**PITTSBURG UNIFIED SCHOOL DISTRICT
HILLVIEW JUNIOR HIGH SCHOOL
TRACK & FIELD MODERNIZATION PROJECT**

**BID ADDENDUM NO. 2
July 20, 2026**

PROJECT: Hillview Junior High School – Track & Field Modernization Project
333 Yosemite Dr, Pittsburg, CA 94565

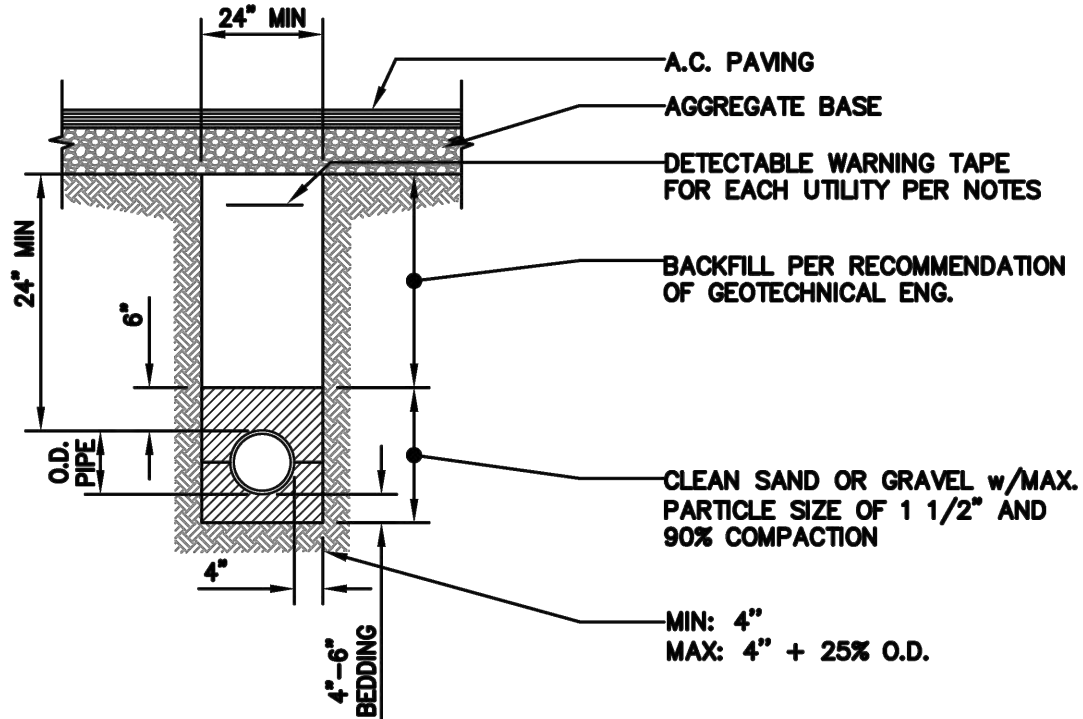
25. Question/Issue: At the north end of the track there is an existing sink hole that needs to be addressed. Has there been any additional investigation into the cause of this issue? How should this be figured into the proposed bids?

Response: While no formal investigation of the sinkhole has been conducted, it is expected that these areas will be infilled in the process installing the new storm drain lines and stabilized aggregate surfacing. Regardless, the sinkholes must be filled and brought back up to specified finished grades. If they reappear after the completion of this Project, further investigation will be done.
